Interactive comment on “Water yield following forest–grass–forest transitions” by Katherine J. Elliott et al.

Anonymous Referee #1

Comments to Author

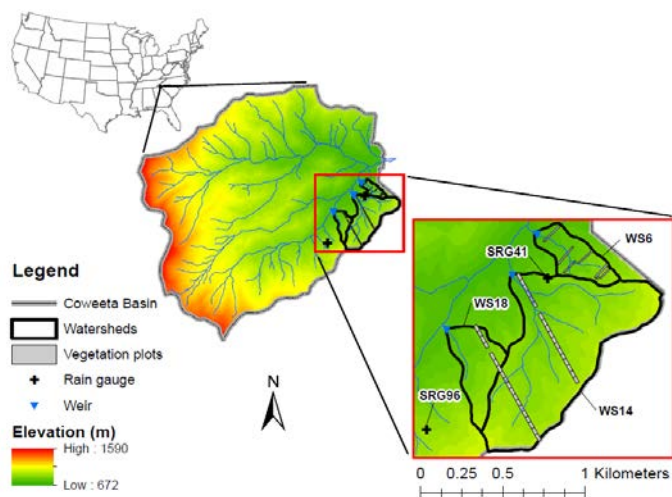
The authors report monthly deviations in Q , but I miss a thorough discussion about potential causes of some aspects of these results. There is a discussion about Q being lower than expected during wet months during the growing season, and I agree with the authors here, but why is there no effect during other months in the growing season (i.e. months that are not classified as wet). Should you not expect to see the same pattern in those months? And I found no convincing explanation to why Q is higher than expected during wet months during the dormant season. Also, according to figure 4b, Q is lower than expected at around average wetness during the dormant season. Why is that?

Response: We discuss why Q is higher than expected during wet months during the dormant season on lines 505-522, here we suggest that because WS6 after treatment does not have rhododendron or hemlock (evergreen species) ET would be lower than in the reference watershed where they remain a component. For example, “More likely the higher than expected Q in the dormant season is due to the lack of evergreen species in the treated watershed.” On lines 510-512.
